Syntroleum

September 12, 2001

In response to your letter of August 23, 2001, Syntroleum is pleased to provide the following responses to your questions regarding our EPAct petition for the DOE completeness and technical review of the Syntroleum petition. For sake of clarity, we have restated your questions ahead of our responses.

Petition Reviewers' Questions

Syntroleum GTL Plant EPAct Process Configurations

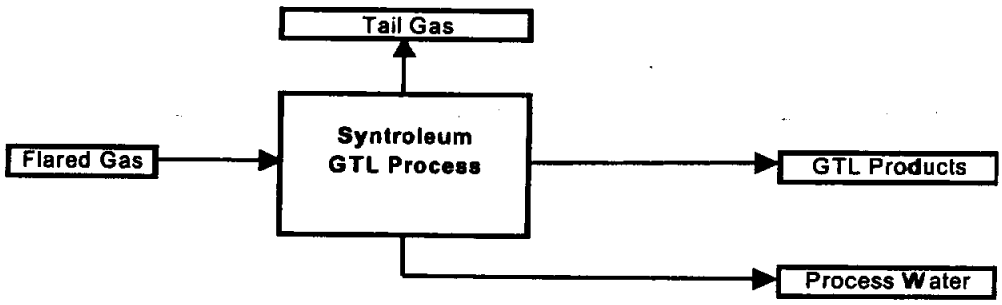
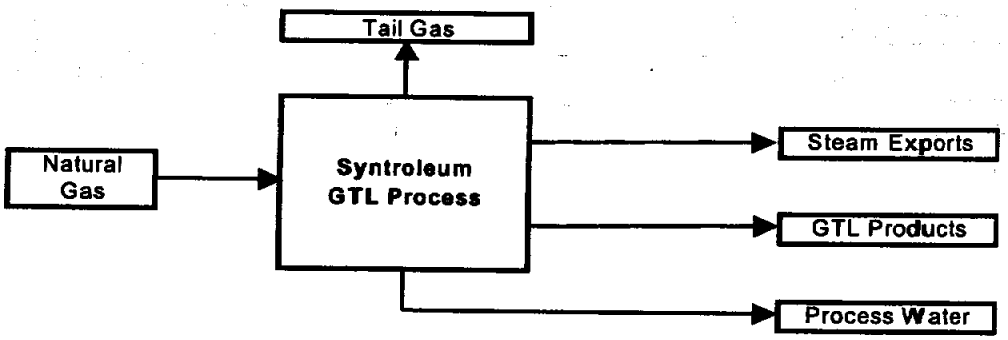
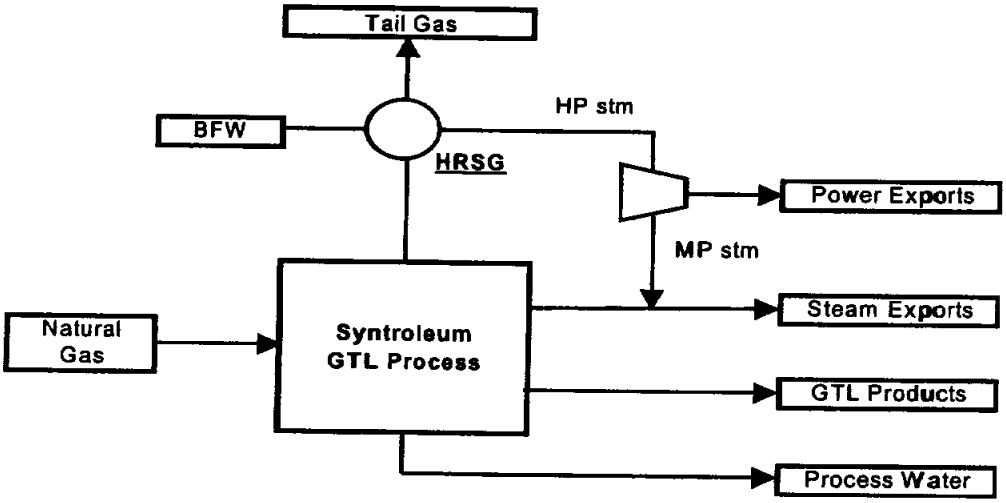
Question 3: In Tables 3 and 4, Syntroleum presents data for two different FTD plant designs – one with steam export only, and the other with steam and electricity export. Oddly, the amount of steam exported with the option of steam and electricity export is greater than the amount of steam exported with the option of steam export only. This may be due to different qualities of steam from the two designs. If so, please specify the pressure and temperature of the steam from each design.

Syntroleum Response: Both the ATR and FT reactions are exothermic. In order to control the process and remove this heat, steam is raised from both of these reactions. Saturated HP steam (700 psia/503 F) is generated in the ATR quench exchanger and is used to provide motive power for various pieces of rotating equipment. Based on the individual plant design and the power train configurations, variable amounts of HP steam are available for export depending on plant design. Saturated LP steam (140 psia/353 F) steam is generated in the FTR steam drums. This steam is used for various pre-heat duties, product upgrading column feeds and general plant use (vessel and pipe steam tracing). The balance is available for export. For the "steam and electricity export" case, HP steam is generated in the HRSG (as described above) and then used to generate electricity in a back pressure turbine with a backpressure of 140 psia, thus creating additional quantities of exportable LP steam and exportable power. Attachment C shows the process configurations used in the three cases presented in our petition revisions dated 2/19/01.
